Application for a Non-Material Amendment following Planning Permission AWDM/1194/24 to increase the overall height of the approved building as a result of necessary structural design requirements and non-material amendment to the car parking plans following reposition of sub-station at The Montague Centre Liverpool Road Worthing West Sussex.

This Planning Letter has been submitted on behalf of **Cayuga 013 LLP** in support of the above Non-Material Amendment (NMA) application at The Montague Centre.

Figure 1 - Permitted Parking Layout

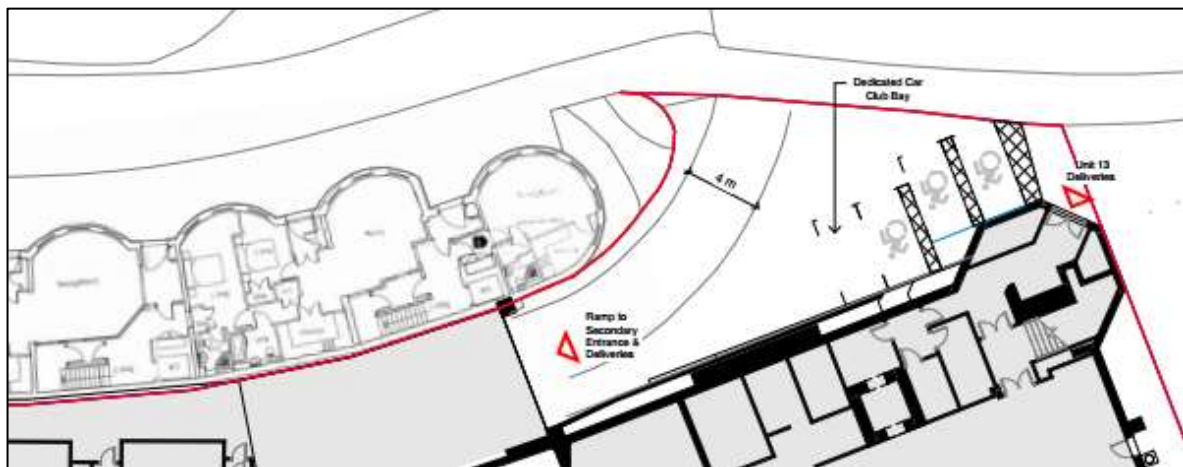
The consented application's approved plans showed 3no disabled spaces and 1no car club space at the bottom of the ramped access. Refer to Figure below.

As discussed with Louise Prew under application reference AWD/0707/25 in which the substation is being moved, the 4no car parking spaces have been re-located at the top of the ramp as shown on Accel's drawings SUB-26 revB and SUB-21 revA.
